## ***Oil and Gas Well RAIs***

Comments concerning oil and gas wells within 2 km of the Proposed Project area:

**LUDEMAN PROJECT**  
 CONVERSE COUNTY, WY

Wyoming Oil and Gas Conservation Commission Permitted Wells Within Two Miles			
REV #	DESCRIPTION	BY	DATE
0	Draw for Review	RMD	6/20/13
1	For Submittal	RMD	6/20/13
2

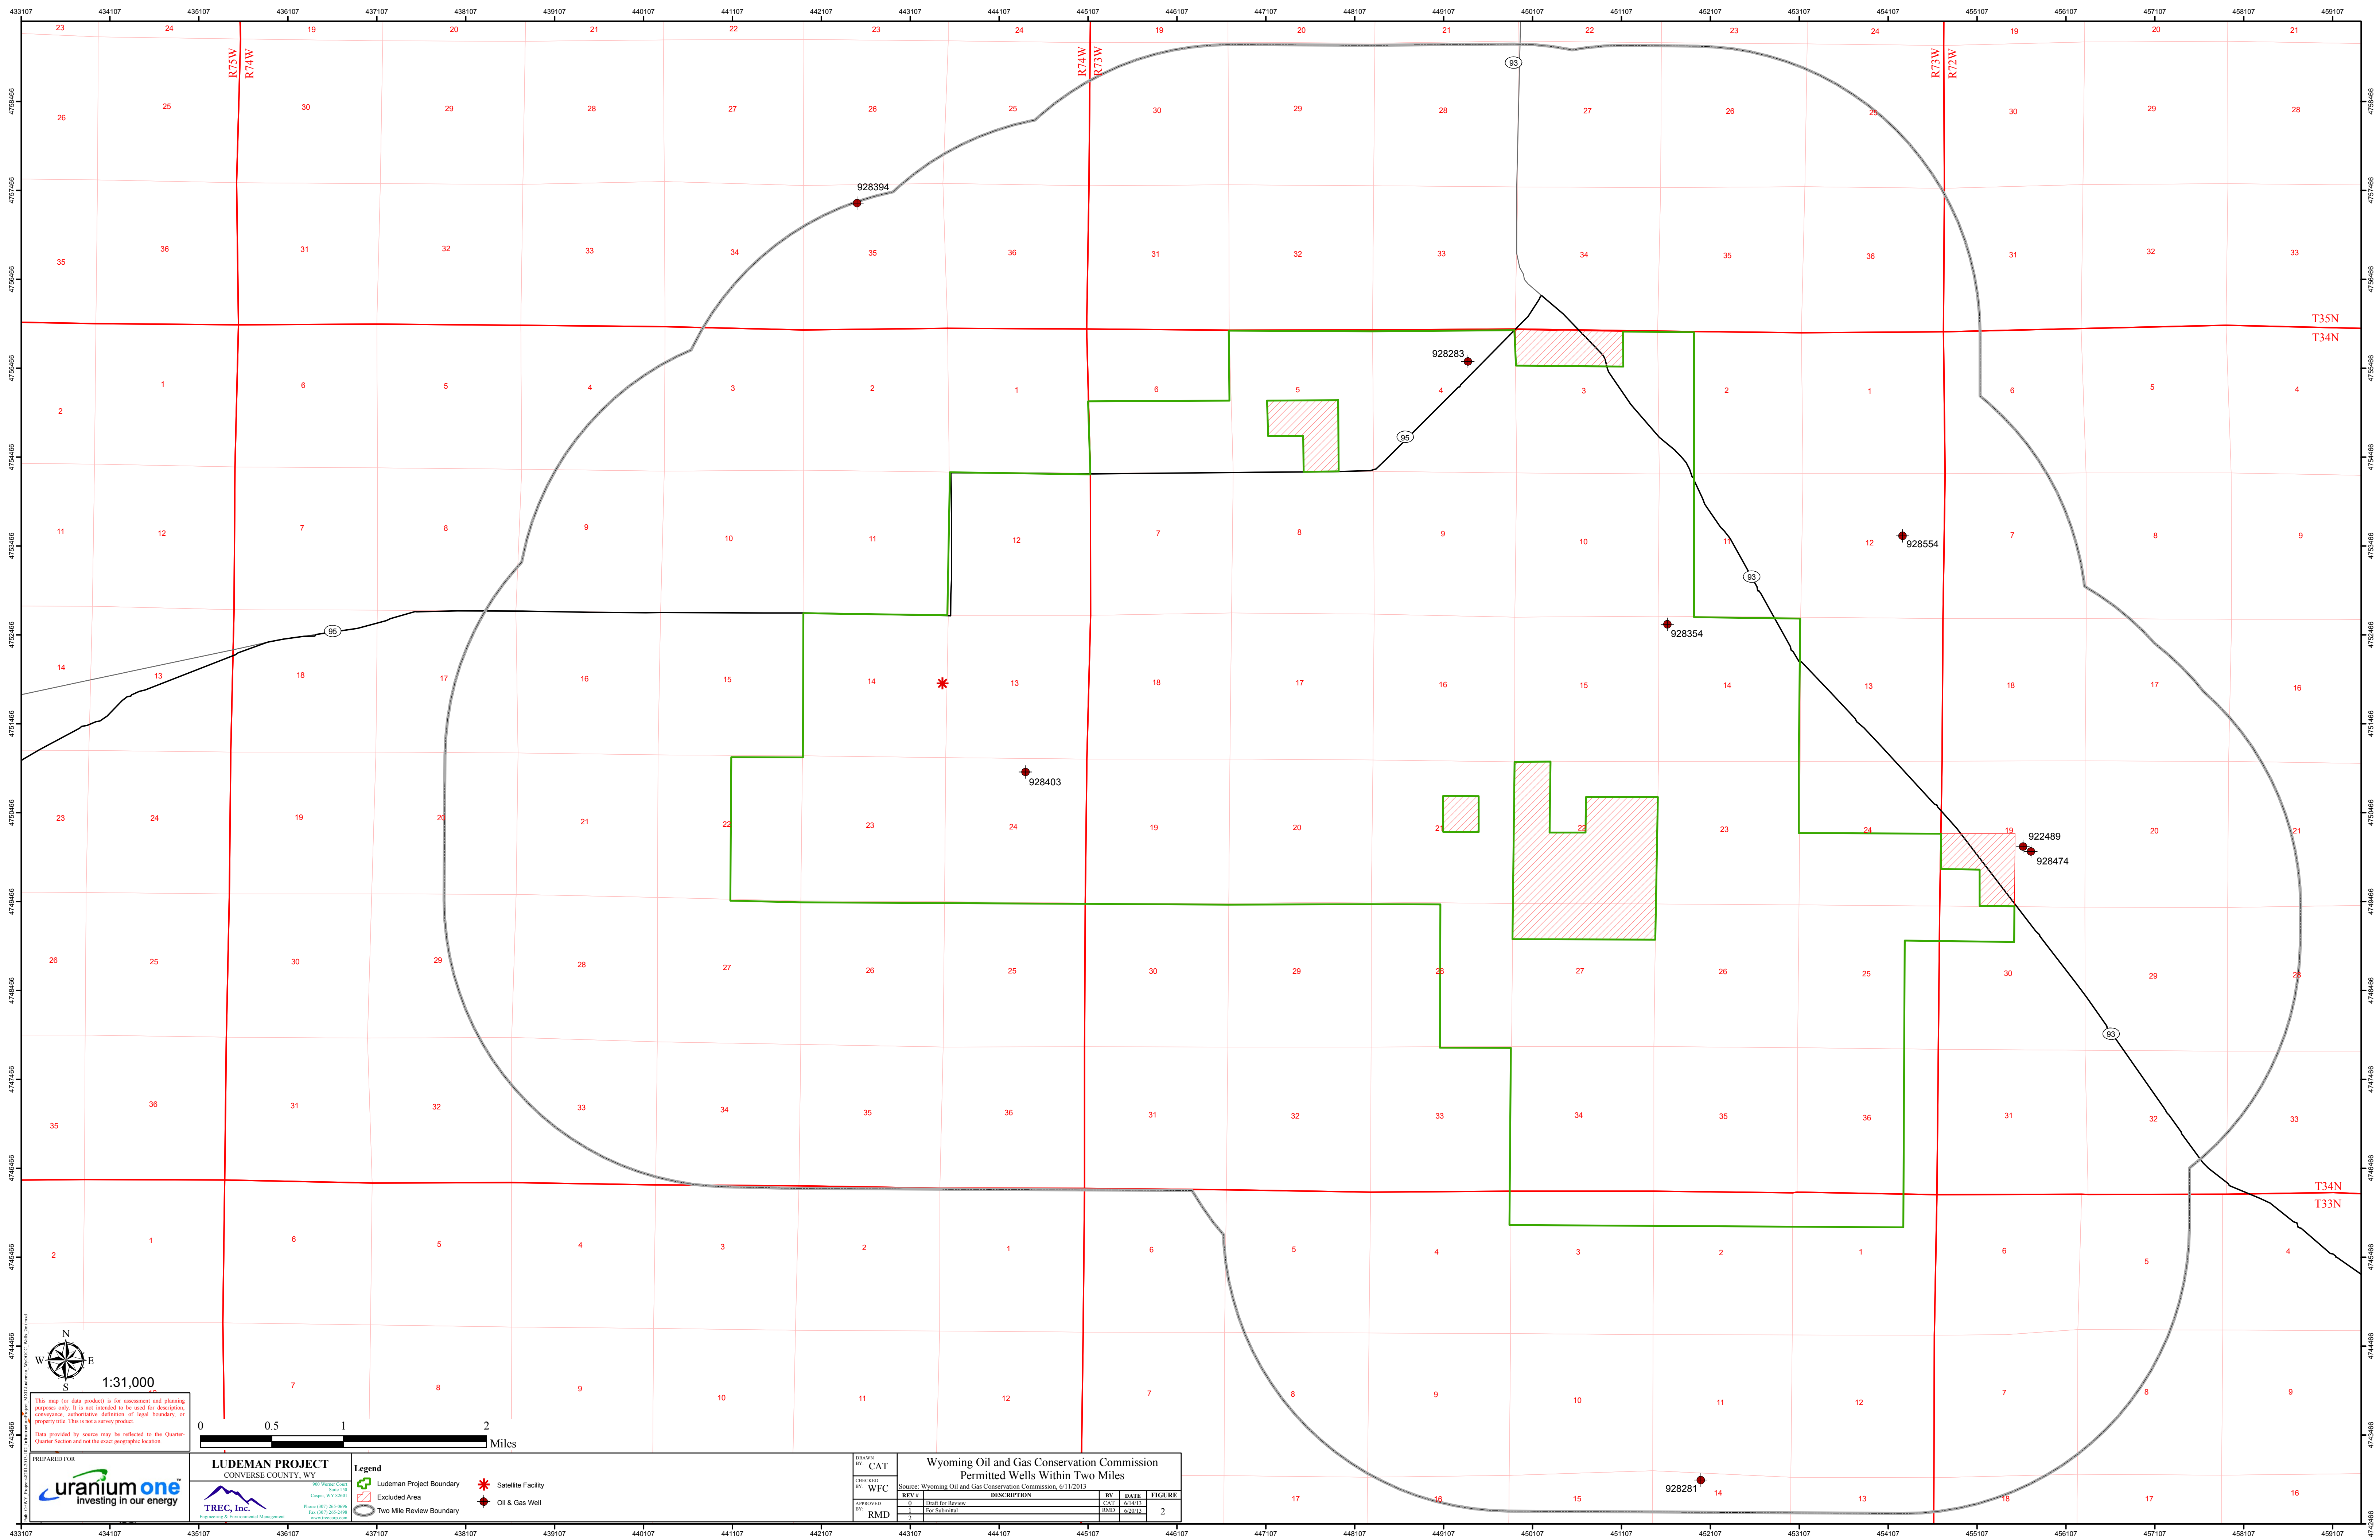
- a) What is the status of the following wells?
  - API 922889
  - API 928353
  - API 928414
  - API 928566
- b) Are there lateral wells and if provide lateral info ( distance and length).
- c) Please confirm correct depth and completion of API 928283. Does not appear to be completed in the Niobrara.
- d) Are the following wells screened in the Niobrara?
  - API 928394
  - API 928474
  - API 928554

The drilling plats for all oil gas wells within 2km is provided on the CD-ROM in the folder labeled “*Oil and Gas Well Plats*”. The plats provide individual well drilling information per the request of the reviewer.

The correct depth and completion information for API 928283 has been updated and provided in the following table. This table has been updated with the most current WOGCC data and will replace the current table within the application. In addition to the table, the associated figure depicting the location of the listed wells is provided below
